National Committee on Uniform Traffic Control Devices

TECHNICAL COMMITTEE: Railroad / Light Rail Transit Technical

TOPIC: Busway Grade Crossings

AFFECTED SECTIONS OF MUTCD: Proposed New Section 8E

Busway Warning Sign

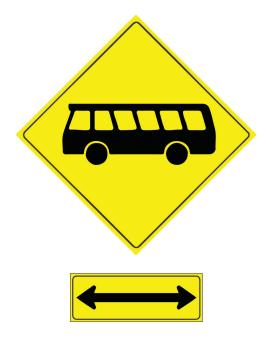
Option: A Busway Warning sign with a one-direction arrow for one-way busways or a two-direction arrow for two-way busways may be used at the crossing point of highway-busway grade crossings where there are no active traffic control devices.

As an alternative to the Busway Warning sign, the legend "TWO-WAY BUSWAY" may be used at two-way busways.

[The design of this sign is consistent with the design of crossing signs in Figures 2C-10 and 2C-11 which use the W16-7P diagonal downward pointing arrow when the sign is placed at the location of the crossing point. FHWA staff has confirmed that they will test alternative bus symbols before final approval of this sign]
